RE: 695 Bicknell Road

I reviewed the drawings and evaluated the neighborhood context. My comments and recommendations on the design are as follows:

EXHIBIT 7

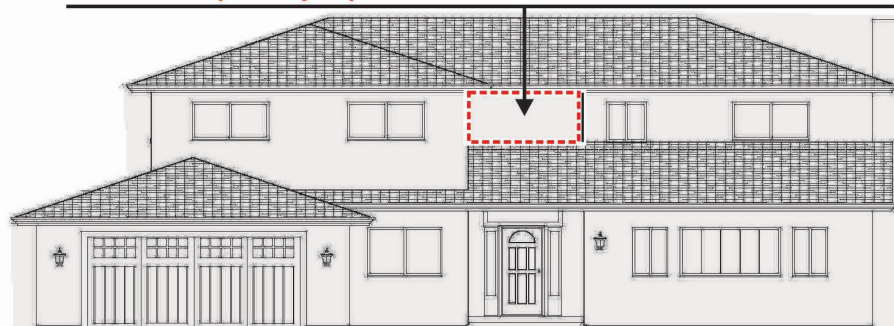
1. There is something missing and not coordinated at the second floor addition over the home entry. The floor plans call for an open space to the floor below but does not show an exterior wall.

Unclear what happens in this area
Second floor plan says open to below but there is no outside wall shown

1. Clarify the second floor plan above the home entry. I am assuming that the front wall of Bedroom 5 will continue in line with the front facade.
2. Add surrounding trim on all windows and doors consistent with Residential Design Guideline 3.7.4.

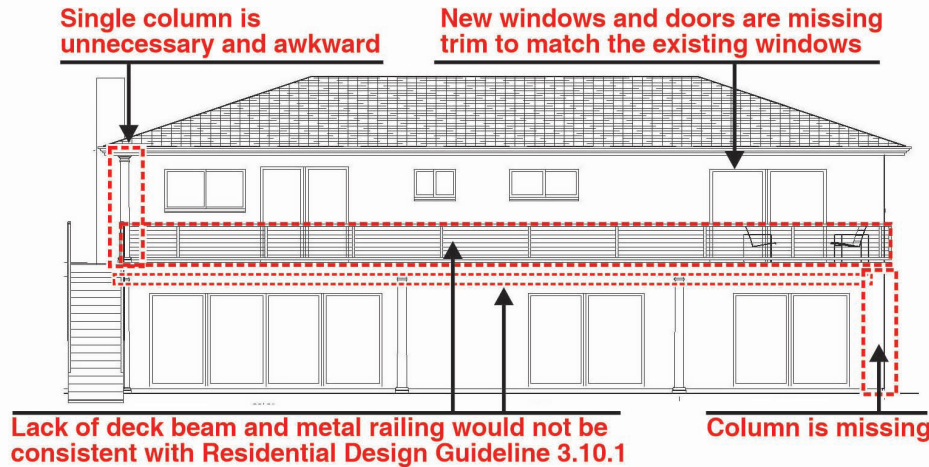
2. New windows and doors have sizes and proportions compatible with the existing house but do not show surrounding trim to match the existing openings as required by the Residential Design Guidelines.
3. The new rear balcony across the full width of the rear facade is missing a supporting column at one end and has an unnecessary and awkward added single column at the second floor.

4. The rear balcony lacks a beam over the columns which would not be consistent with Residential Design Guideline 3.10.1.
5. The metal railing at the rear balcony would not be consistent with Residential Design Guideline 3.10.1.

3. Add the missing ground floor column at the balcony and remove the random second floor column.
4. Add a beam across the columns at the rear balcony.
5. Use a wood balcony railing in lieu of the proposed metal railing.

APPROACH A

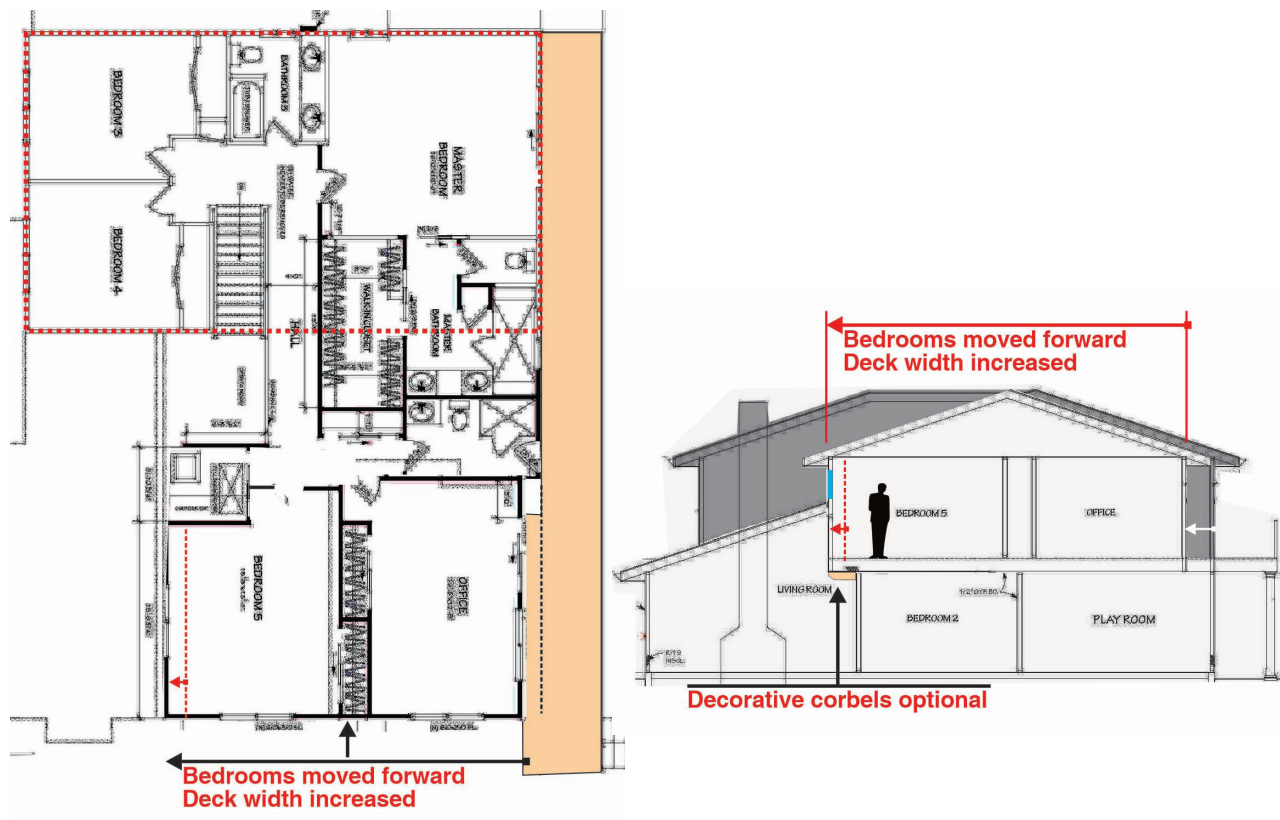
The simplest approach would be to shift Bedroom 5 and the office a bit toward the home frontage so that the first floor roof peak would hit the wall plane, eliminating the roof drainage toward the building face and maintaining the proposed windows. This is shown in the plan and section illustrations below. An option would be to retain the rear wall at the office in alignment with the adjacent rear wall by increasing either the depth of Bedroom 5 or the office.

The downside of this approach as shown is that a portion of the second floor Bedroom 5 volume would intrude into the first floor elevated ceiling space.

APPROACH B

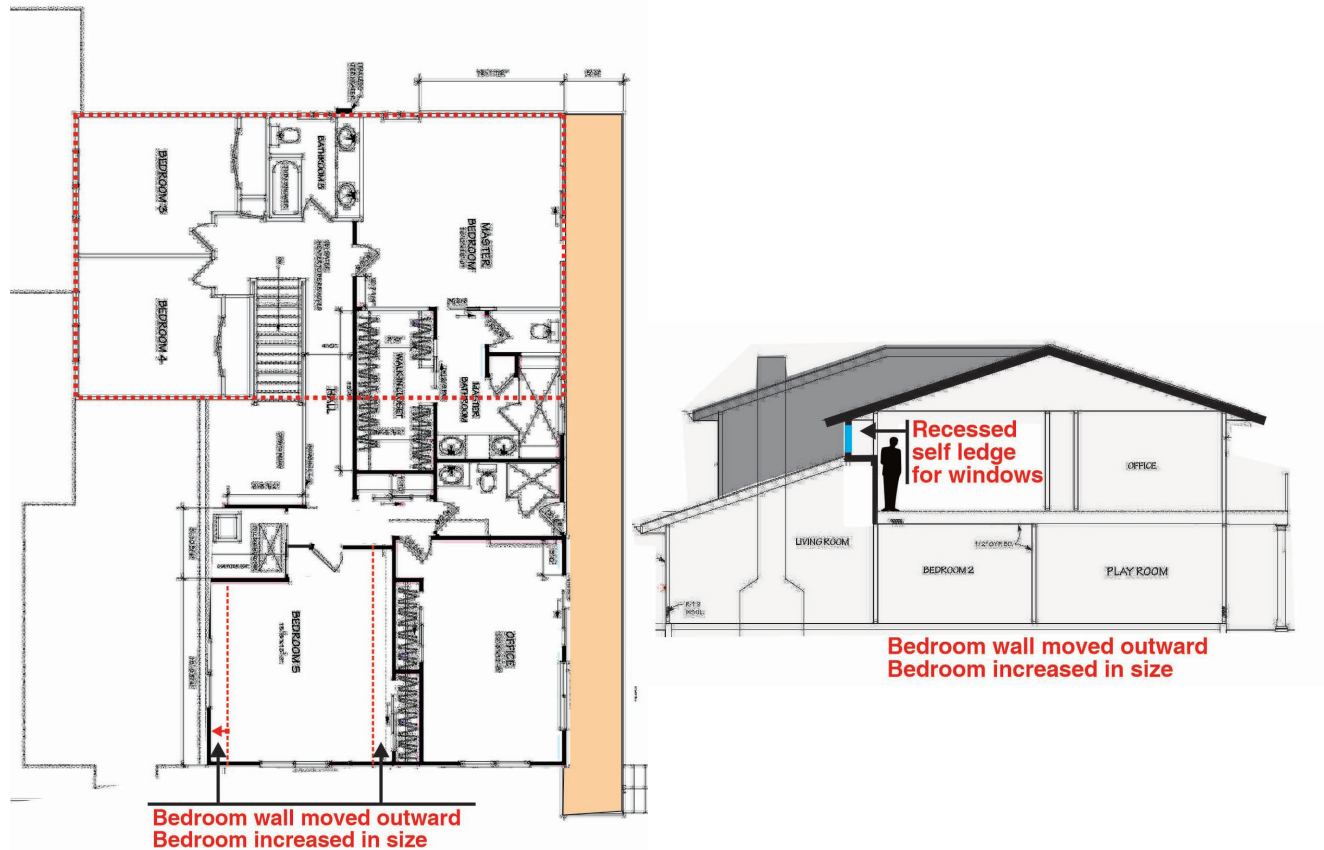
A similar approach that would leave the first floor Living Room volume untouched looks awkward in section but would be a simple fix. It would align the Bedroom 5 wall with the Living Room wall below and add an extended window ledge to bring a wall facade out to match the first floor roof ridge.
